Planning for Wind Energy in the DRECP: CalWEA's Proposed Concepts

California Wind Energy Association
Presentation to DRECP Stakeholders
November 28, 2011

(This document also serves as CalWEA's comments on the DRECP Preliminary Conservation Strategy.)

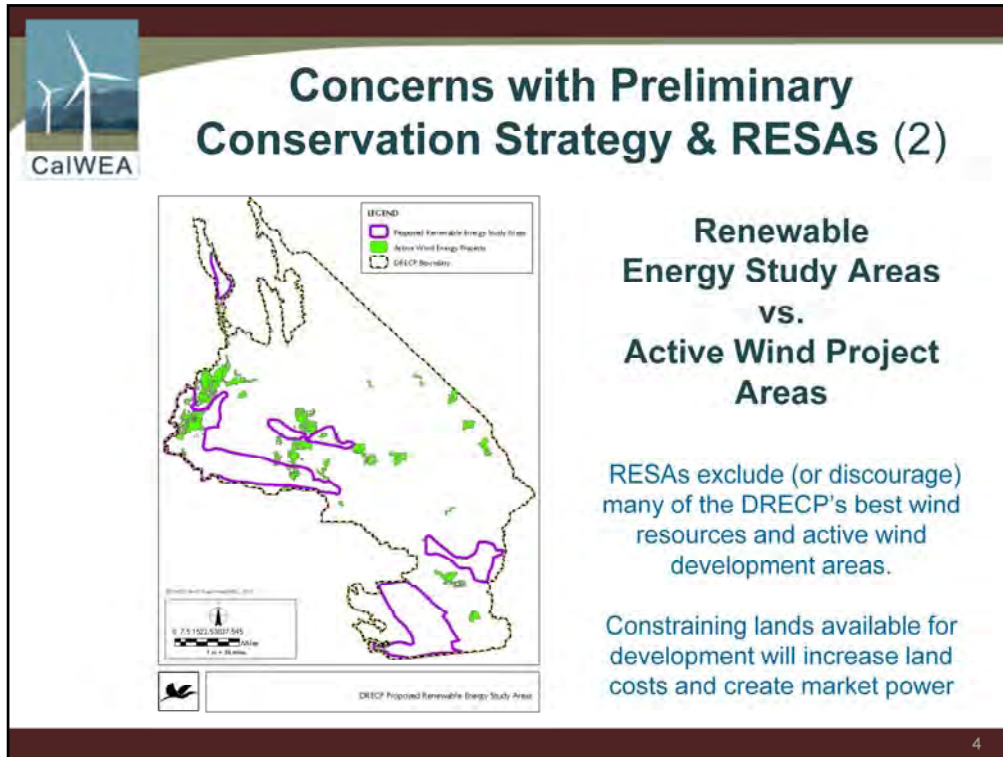
This slide shows areas of current wind project developments (in green), indicating the areas that developers have identified as the most promising, each spending 100's of thousands of dollars in the process. You can see that the RESAs do not include the majority of these areas.

Assuming that RESAs are intended to contain development to these areas (or to provide streamlining benefits only in these areas – meaning it will be a tough slog outside of these areas), they exclude many of the DRECP's best wind resources and active wind development areas.

Concerns with Preliminary Conservation Strategy & RESAs (3)

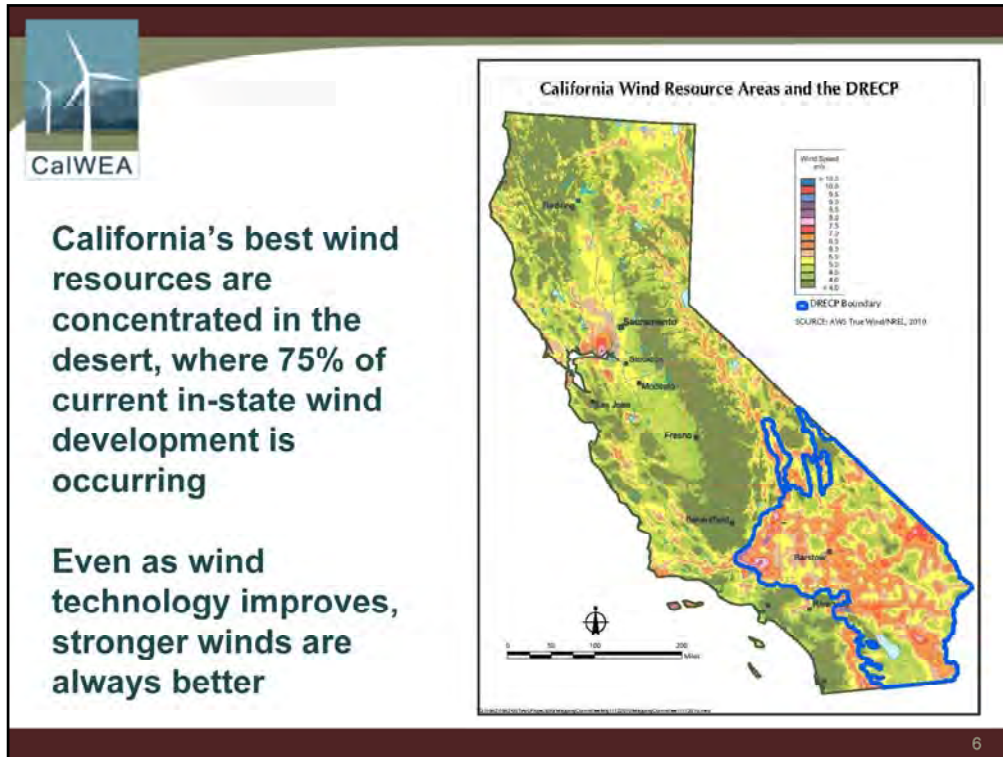
- ⤴ Vast “moderate to high biological value” area
- ⤴ No recognition of variation or particular sensitivities within
- ⤴ All of equal value for mitigation, conservation?
- ⤴ Greater definition would indicate areas compatible with wind development

This is the PCS map of “moderate to high biological value” areas – the vast majority of the DRECP area.

The solid shade of yellow presumes that there is no variation within this area – no areas more sensitive than others

Are all areas of equal value for mitigation, conservation? The considerations going into the reserve design are much more refined than this.

Greater definition would indicate areas that are more or less compatible with wind development (depending on the specific sensitivities).
